Urban Design Assessment: Park Apartments Phase 2

Applicant drawings dated 01-24-23

Prepared by: Brian Peterson, AIA, Urban Designer, T.O.C.H.

02-22-23

1st COMMUNITY DESIGN COMMITTEE REVIEW / 1.24.2023 A1.01 - CONCEPTUAL SITE PLAN AT GRADE

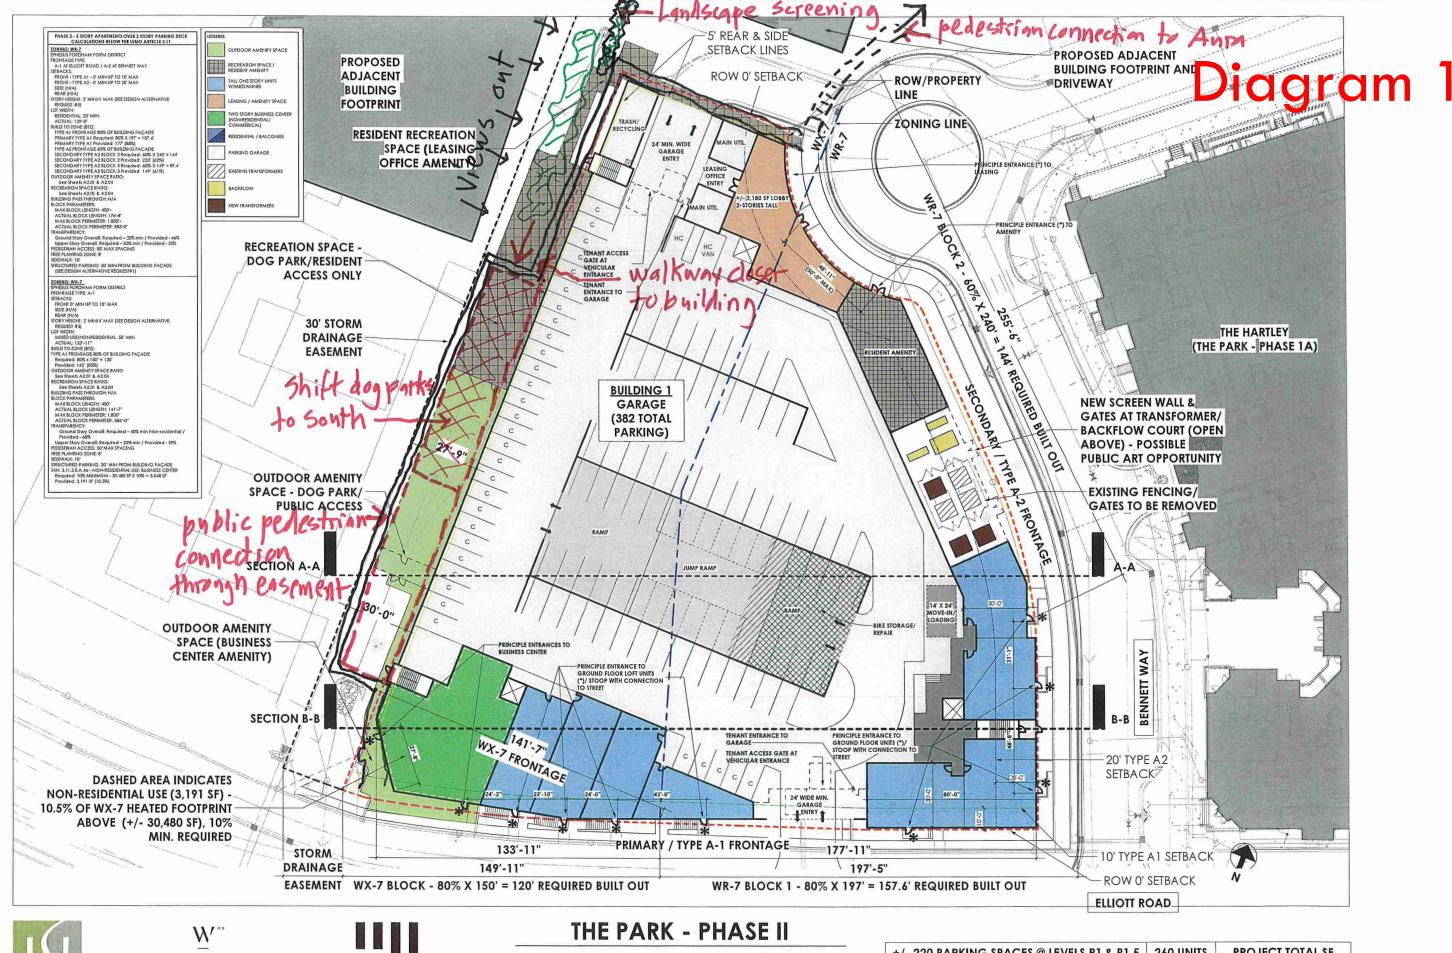
- 3. An outdoor amenity space is proposed along the western side of the property in the form of two dog parks, some green space, and a pedestrian connection. Consider moving the dog parks to the south to not have the dog park directly across from the ground floor apartments in the neighboring Aura Blue Hill building. (Applicant will consider the possibility for this: the location of the existing storm water outlet and its need for access complicates matters.)
- 4. Provide a public pedestrian connection along the entire easement. Move the sidewalk closer to the building in the area where the neighboring apartments are located. Provide landscape plantings in the zone between this sidewalk and the property line to help screen views of the adjacent ground floor apartments in Aura. (Applicant will investigate the possibility for incorporating this.)

5. Provide a landscape hedge or other screening in the area at the end of the entrance drive to the parking structure, to help keep headlights from shining in the adjacent apartments in Aura. (Applicant will consider options for landscape screening.)

Diagram 2

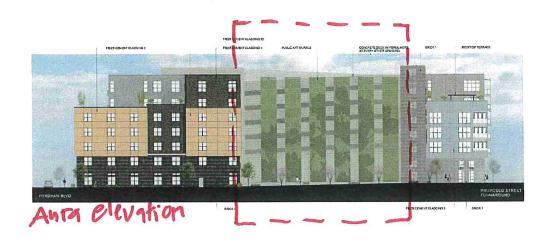
- 10. On the west elevation, where the parking levels are exposed, suggest using architectural screening rather than louvers. Consider an "art mural" (like what is being proposed on the Aura parking structure) or other enhancements especially along the ground floor level, which could provide a more interesting backdrop to the dog park spaces (see attached diagram 2). (Applicant will consider these ideas.)

- Screening other than lonvers - art on ground floor - see Aura

Diagram 3

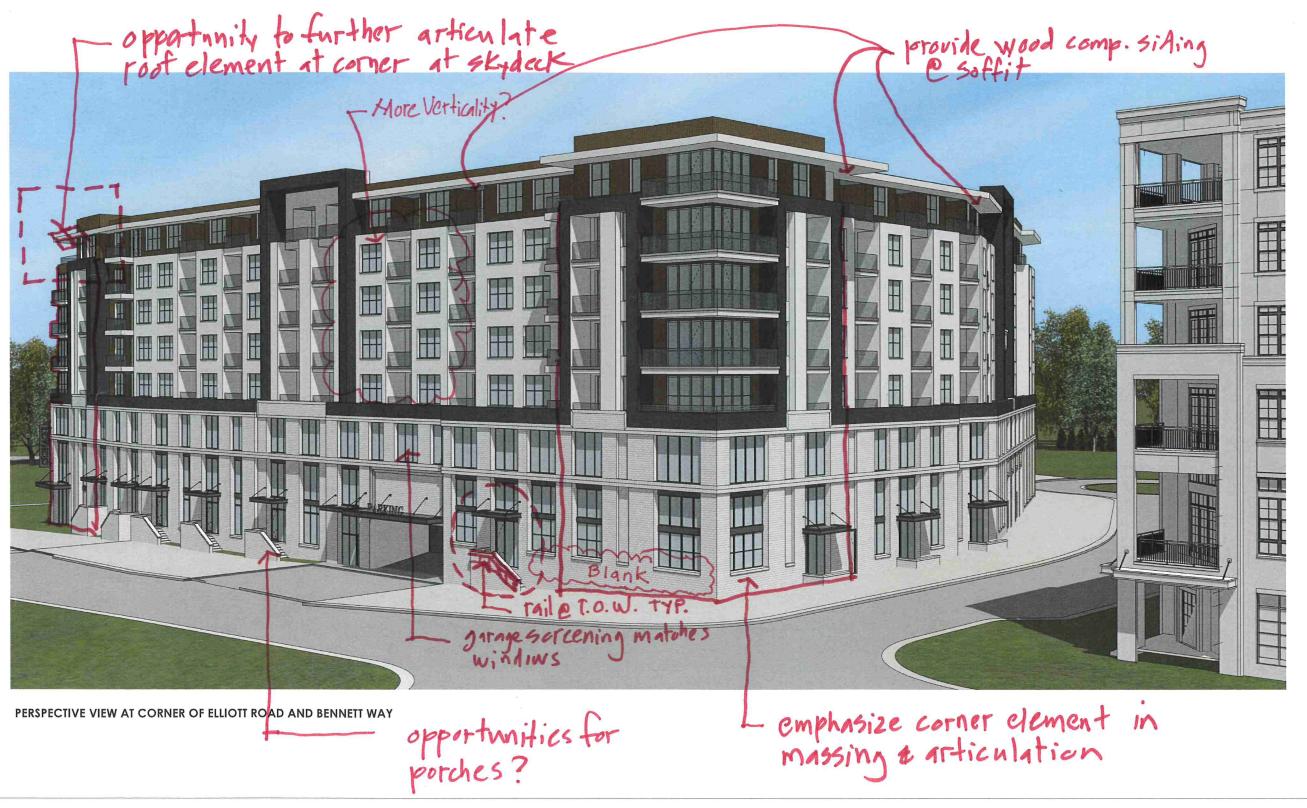
- 12. Consider further massing definition of the corners along Elliott Road, especially at Bennet and Elliott, (see attached diagram 3) by slightly projecting out the corner mass, utilizing reveals, and other means to express verticality. (The current design has emphasized the corner definition by utilizing a backdrop of vertical bands of dark colored materials that cut through the "plinth" and reach to the ground. A similar approach is being applied to the southwest corner of the building).
